RFP#16-18
FOUNDRY PLACE PARKING
GARAGE PERCENT FOR ART PROJECT
PORTSMOUTH, NH
November 28, 2017

Addendum#1

This Addendum forms part of the original document marked: RFP#16-18 Foundry Place Parking Garage Percent for Art Project.

SHEET NOTES

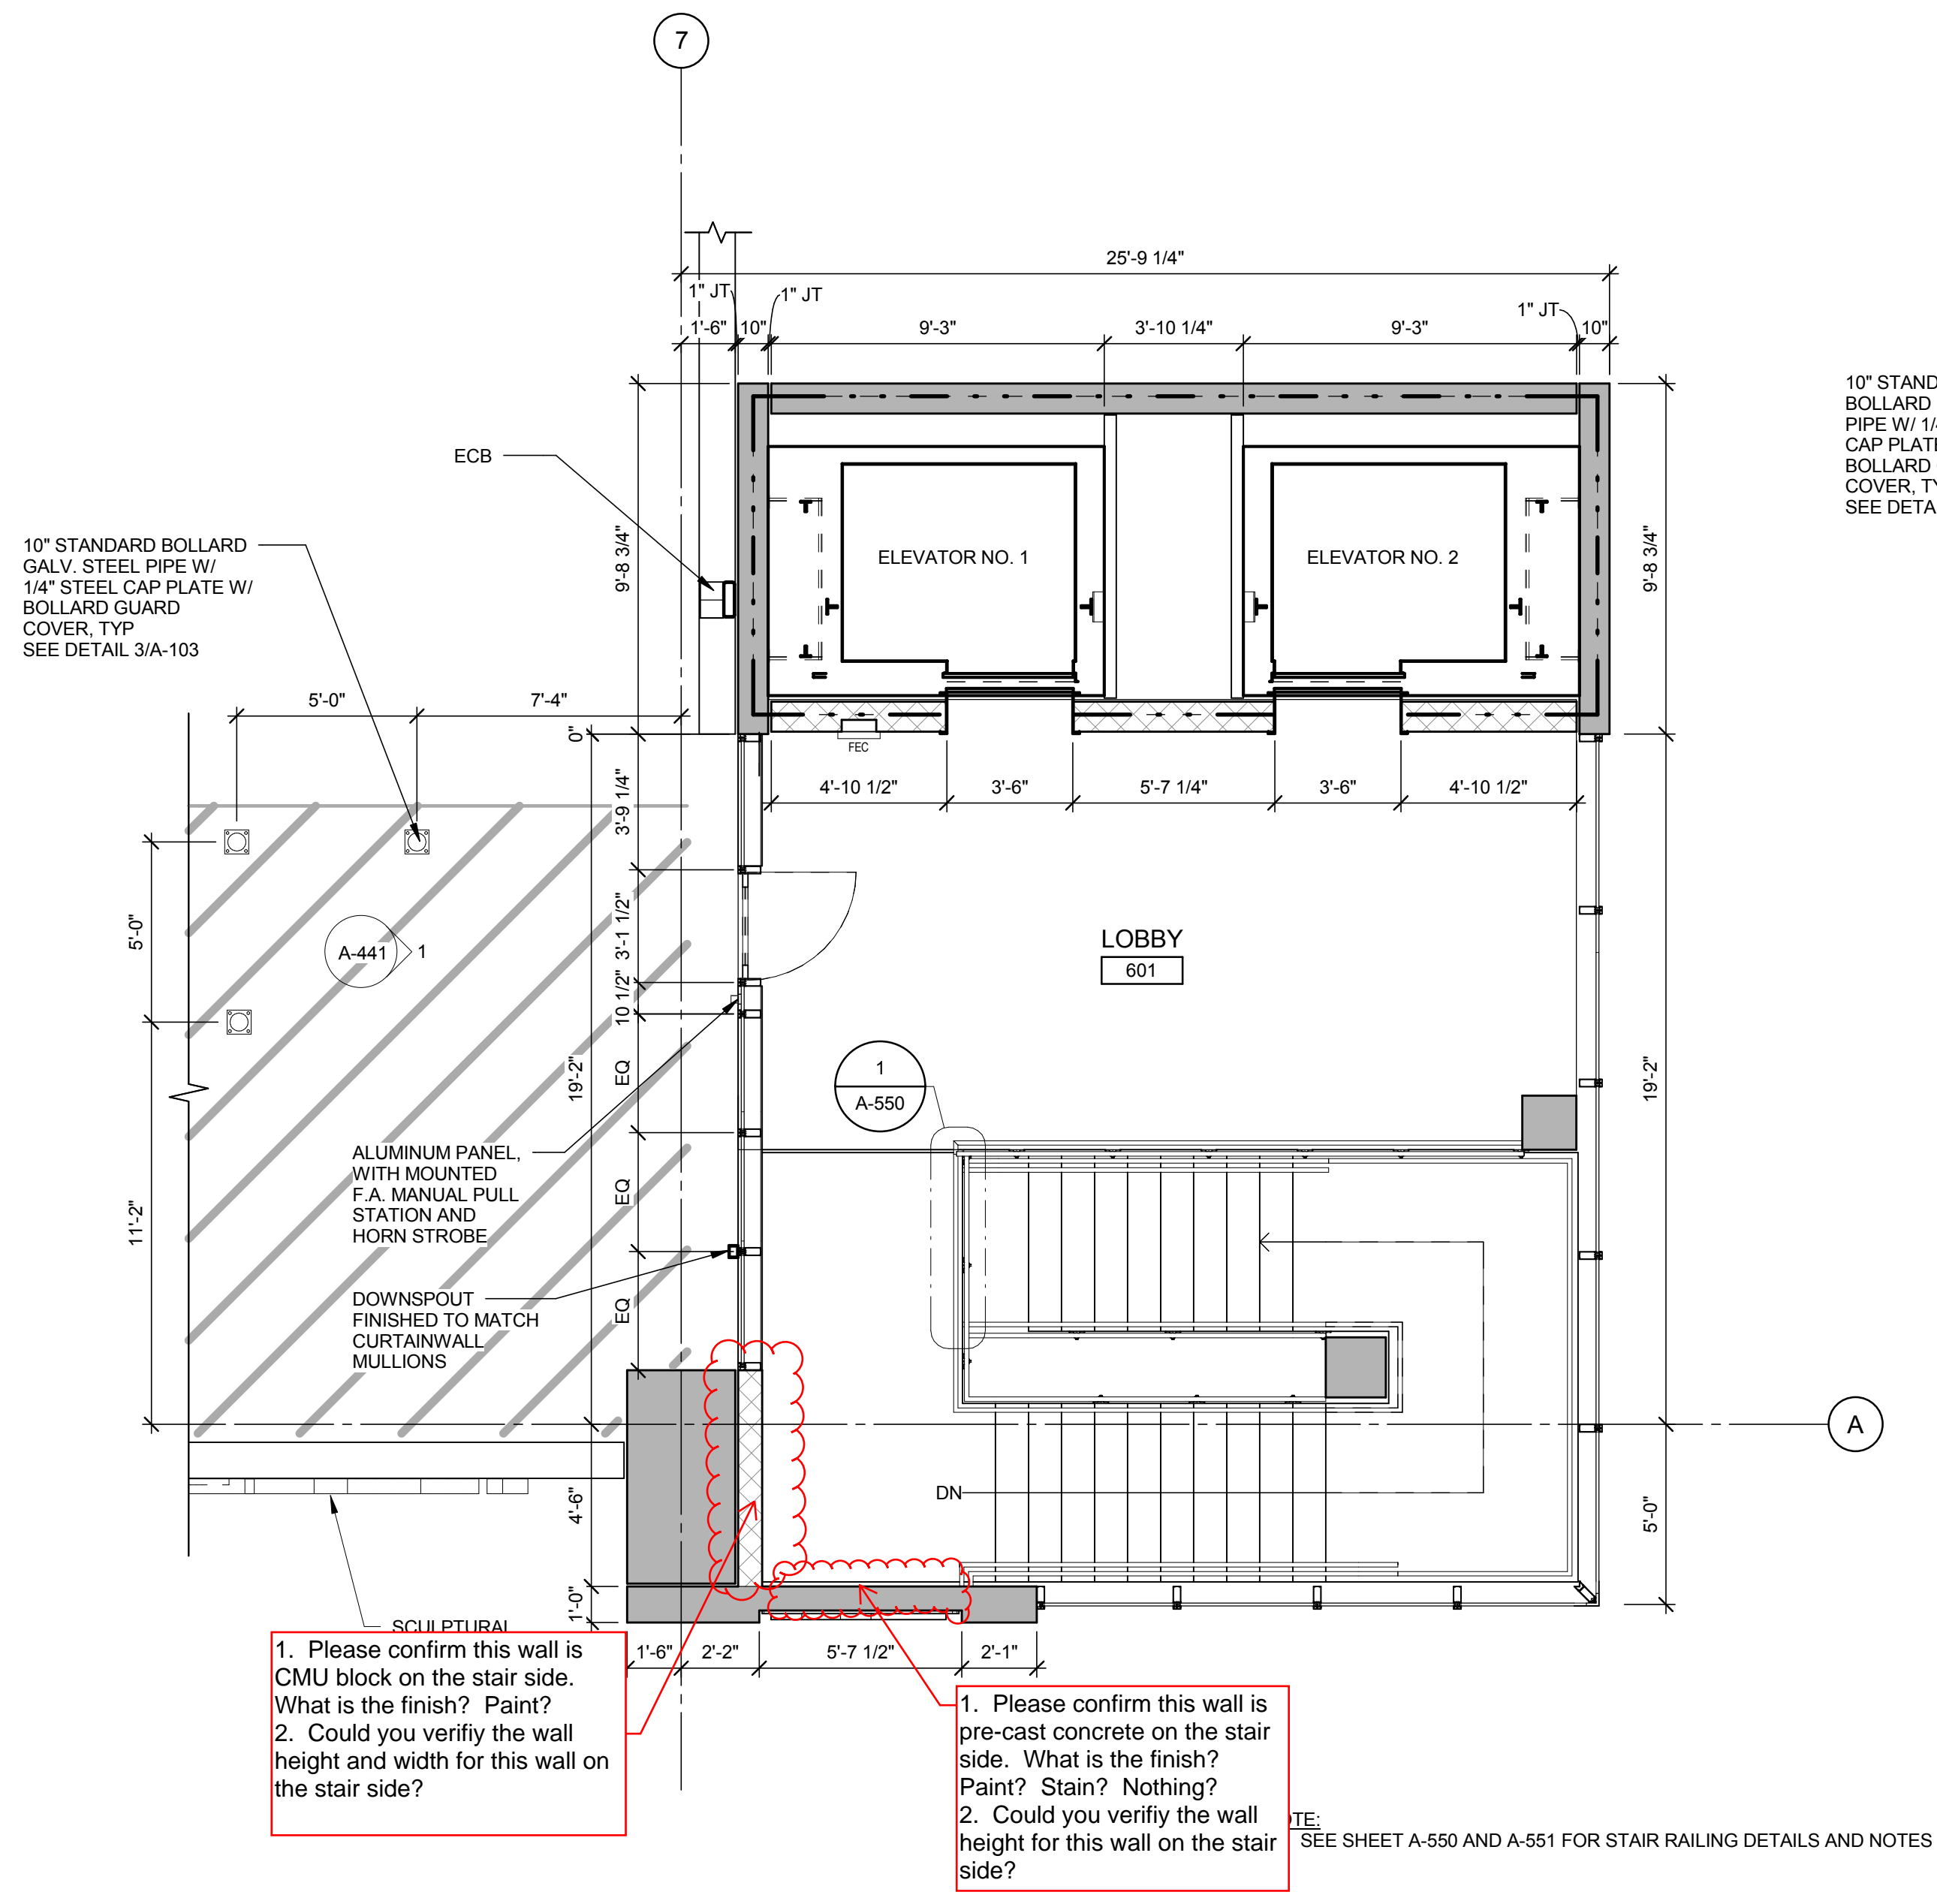
Q: Could you perhaps highlight on the floor plan(s) where the long blank interior wall that could be used for art is located?

Q: If there are additional walls that would contain a decent amount of blank space, could those be highlighted (drawings A101 through A106)?

Q: What is the finish of the wall, and what are the dimensions - both width and height?

Q: On any of these walls, including the ones highlighted on the attached plans, could you call out where any interior signage such as floor numbers, exit signs, etc. would be?

A: See attached annotated plan(s).

A: See attached annotated plan(s).

A: See attached annotated plan(s).

A: See attached annotated plan(s).

A-411

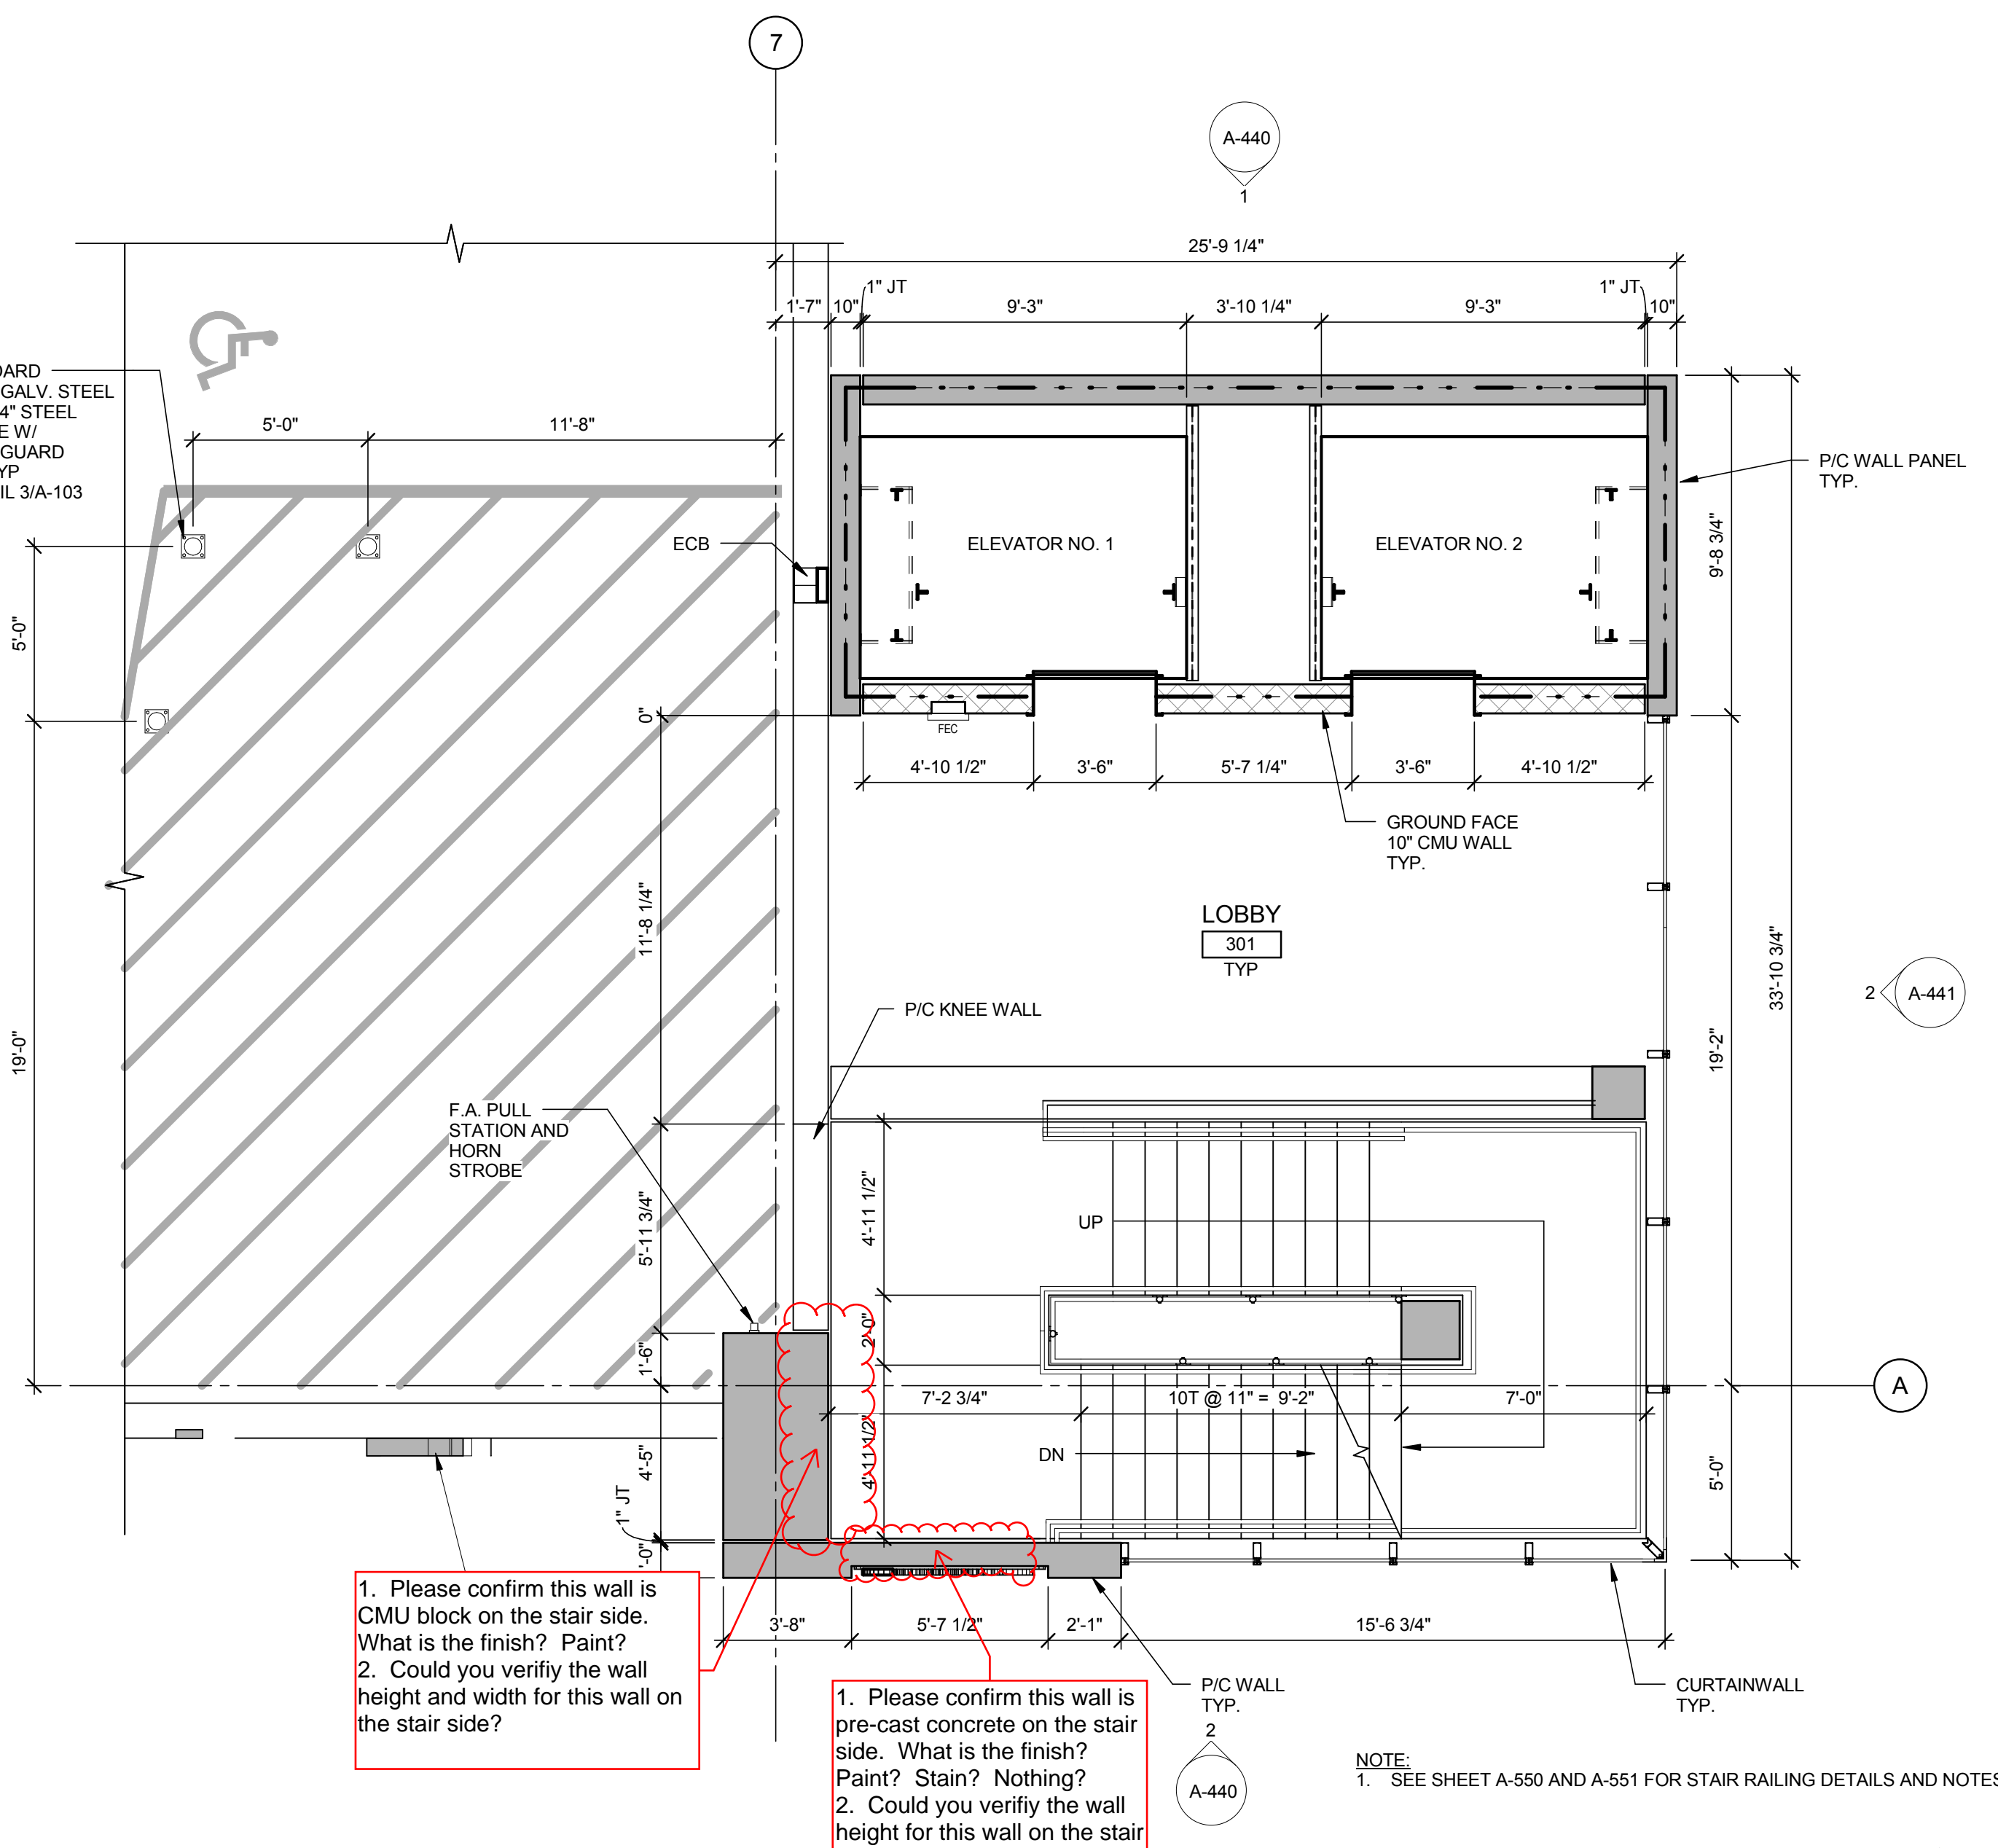
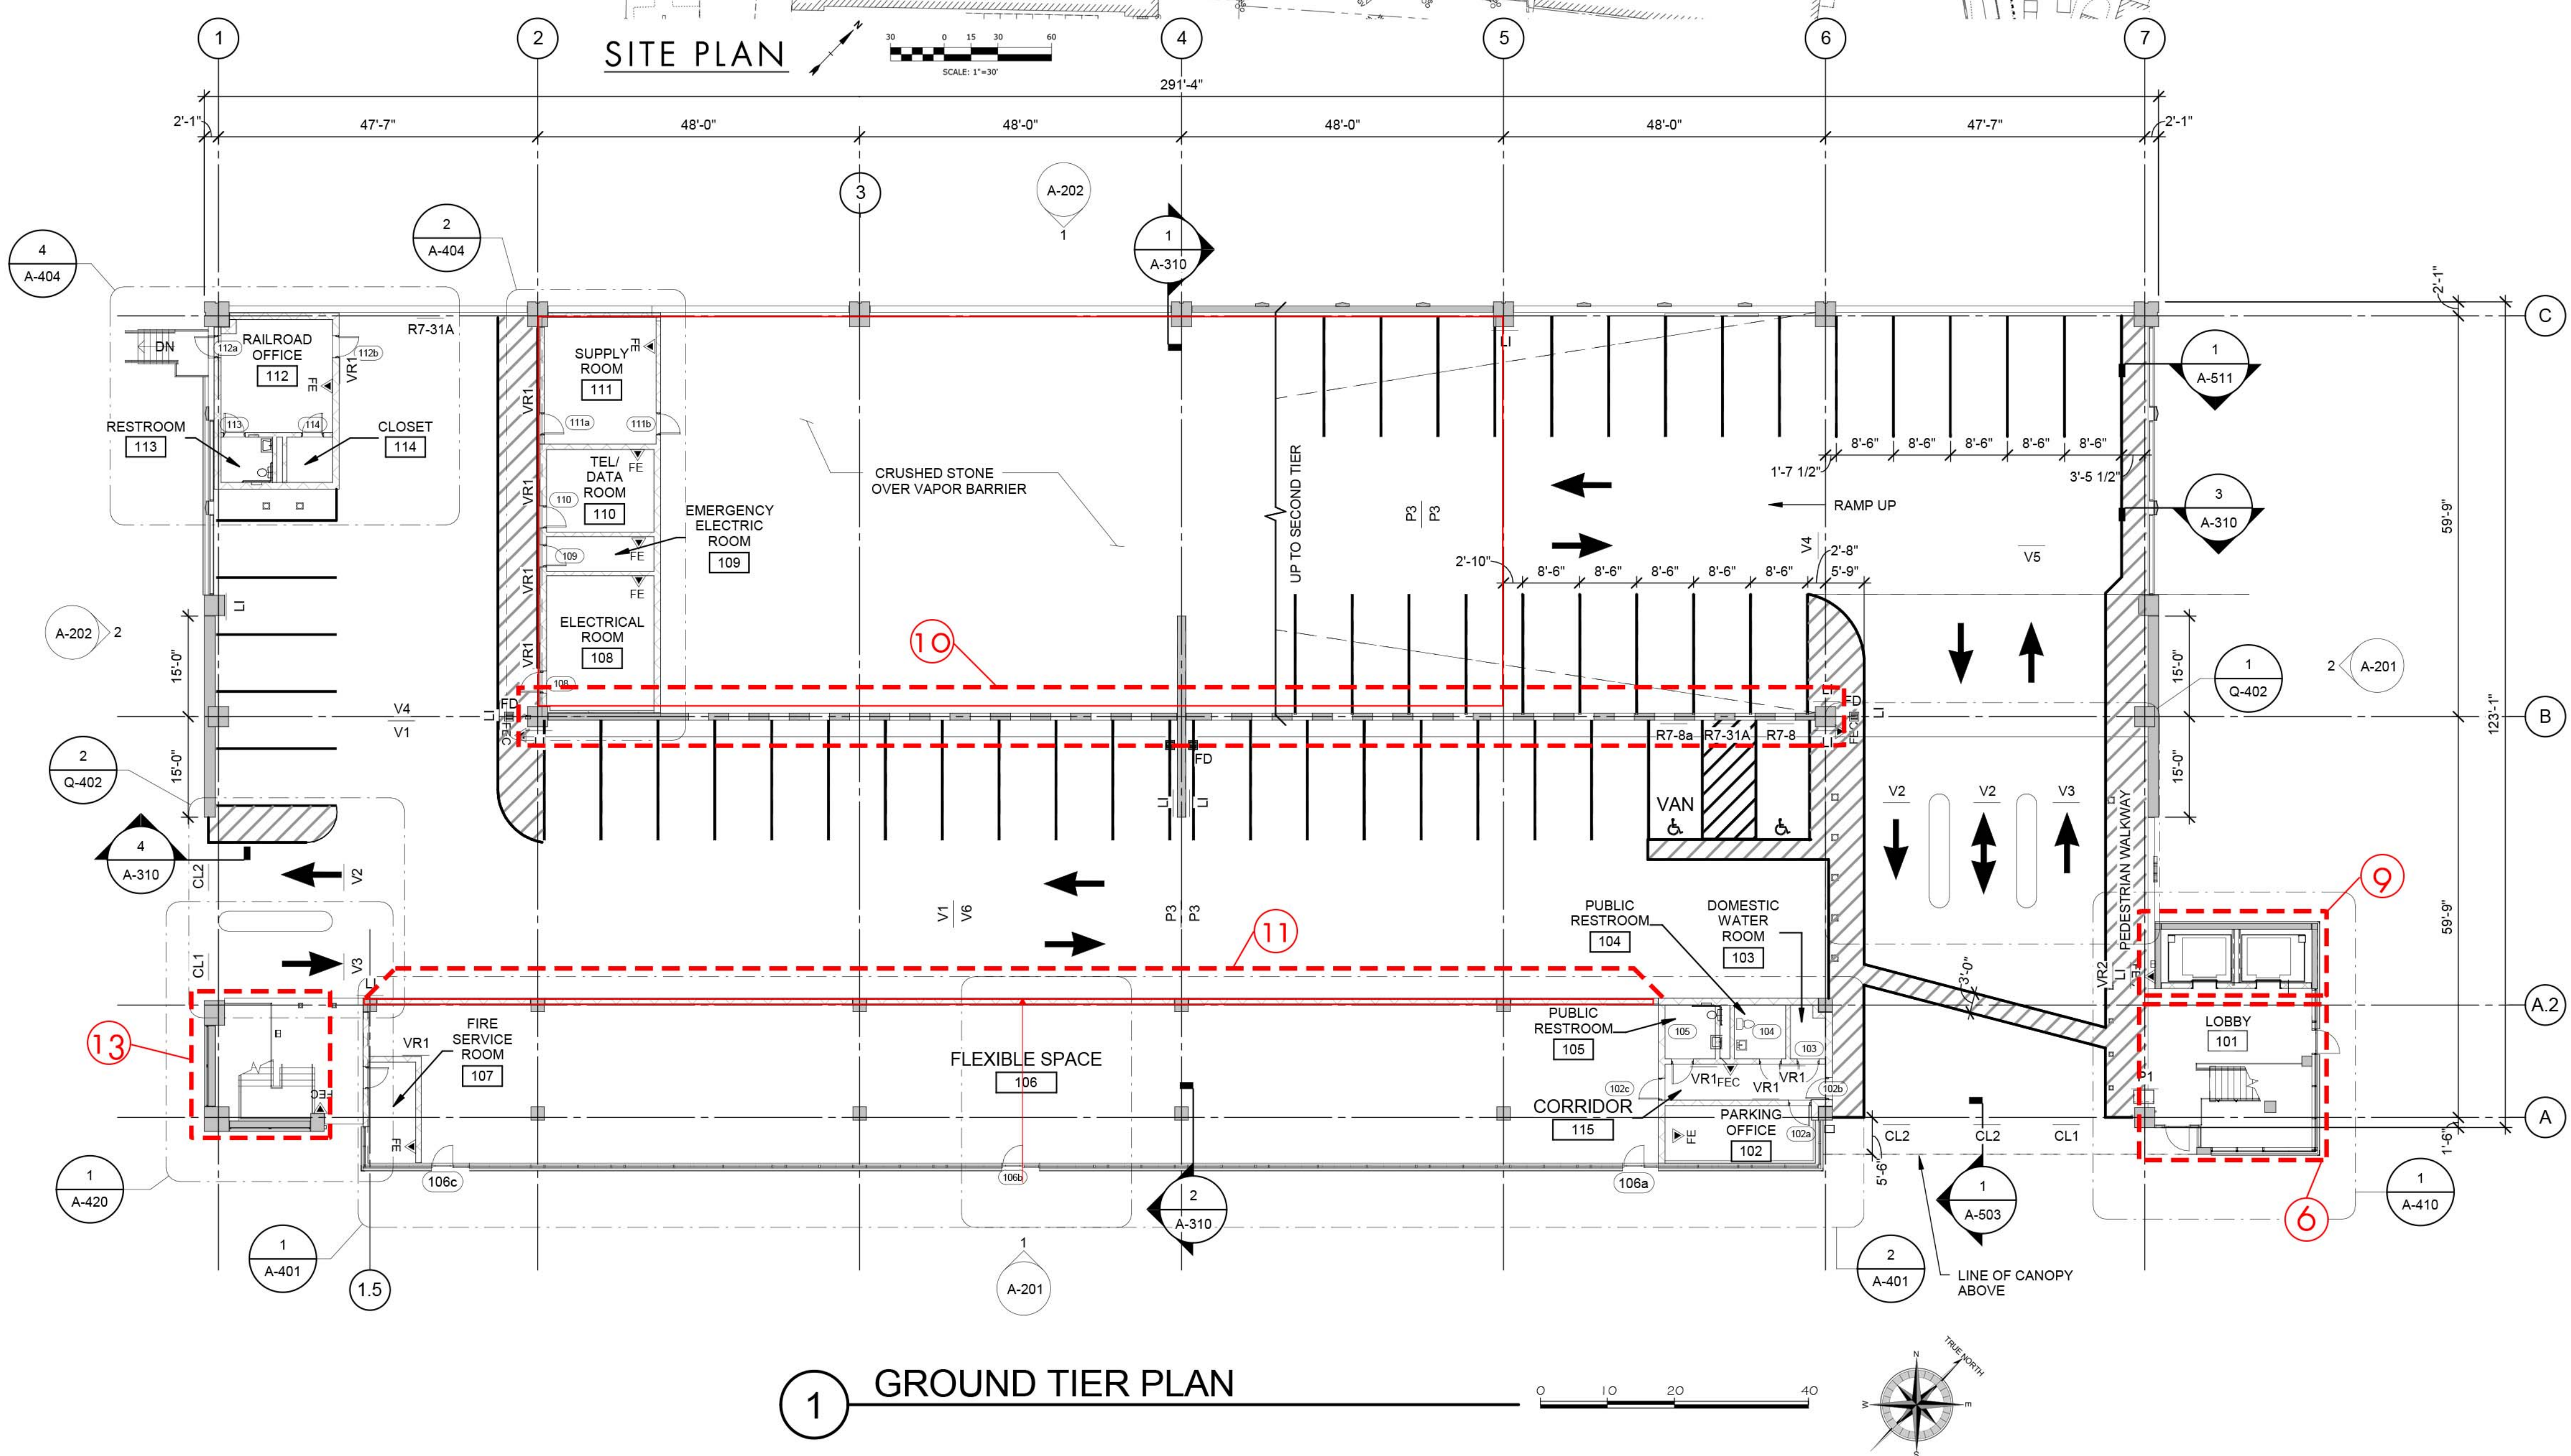
1. Please confirm this wall is CMU block on the stair side. What is the finish? Paint?
2. Could you verify the wall height and width for this wall on the stair side?

1. Please confirm this wall is pre-cast concrete on the stair side. What is the finish? Paint? Stain? Nothing?
2. Could you verify the wall height for this wall on the stair side?

1. Please confirm this wall is CMU block on the stair side. What is the finish? Paint?
2. Could you verify the wall height and width for this wall on the stair side?

1. Please confirm this wall is pre-cast concrete on the stair side. What is the finish? Paint? Stain? Nothing?
2. Could you verify the wall height for this wall on the stair side?
